Syncrude Canada Ltd.
Application for Aurora North
Tailings Management Plan

June 13, 2018

Decision 20180613A: Syncrude Canada Ltd.; Application for Aurora North Tailings
Management Plan

Figure 1. Legacy fluid tailings profile

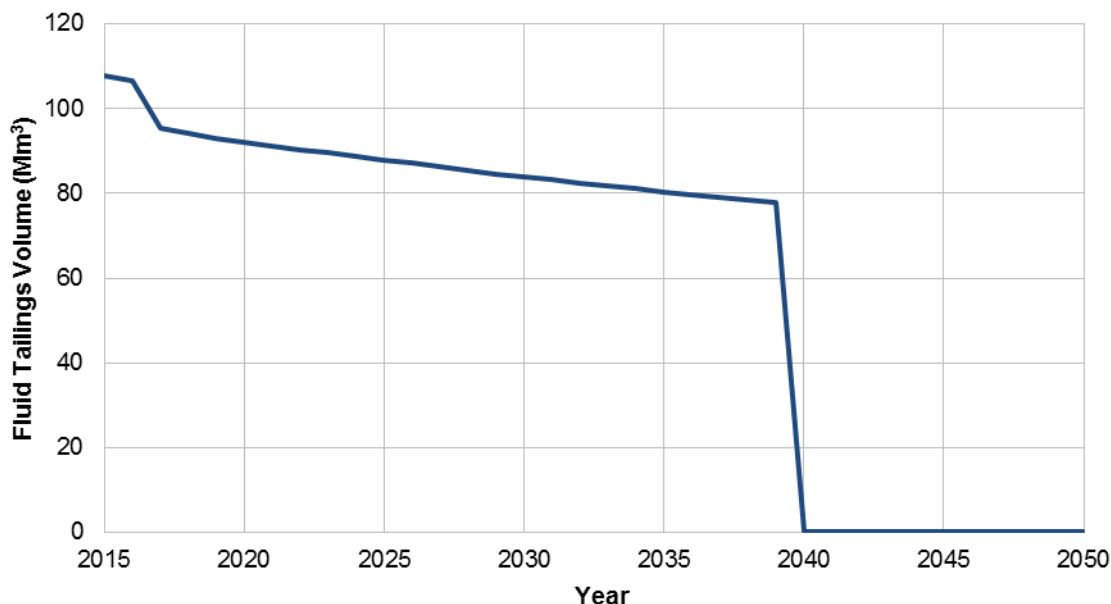
[36] SOC filers raised three concerns with respect to Suncrude’s legacy fluid tailings profile.

[35] Syncrude is required to achieve the legacy fluid tailings profile as shown in figure 1.

Figure 2. New fluid tailings profile

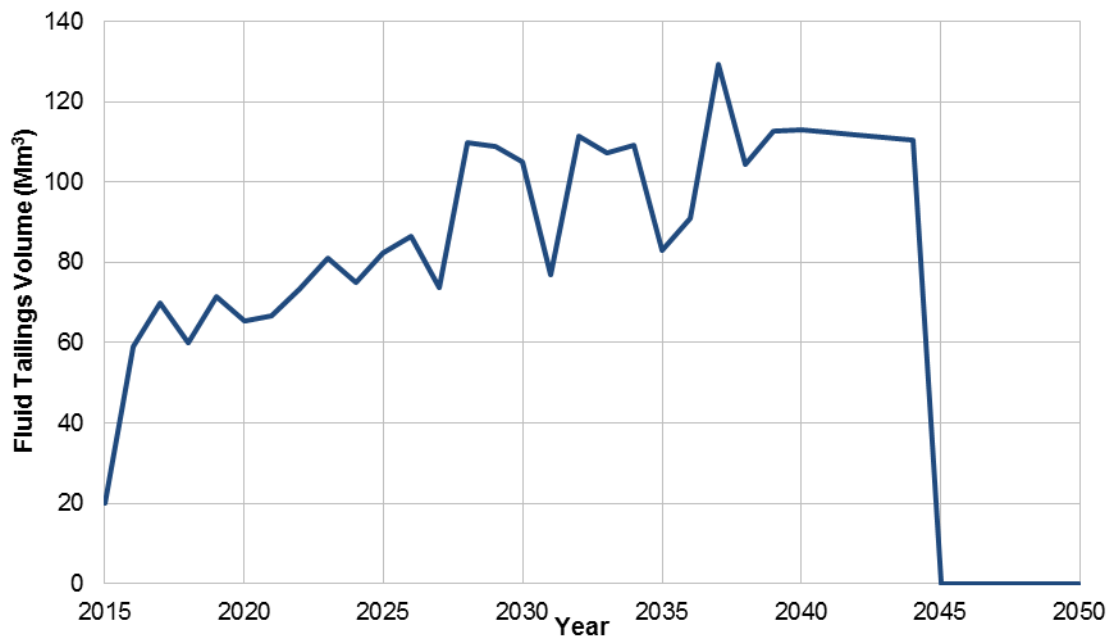
[46] SOC filers and the AER have several concerns regarding Syncrude's new fluid tailings profile:

[45] Suncrude is required to achieve the new fluid tailings profile as shown in figure 2.
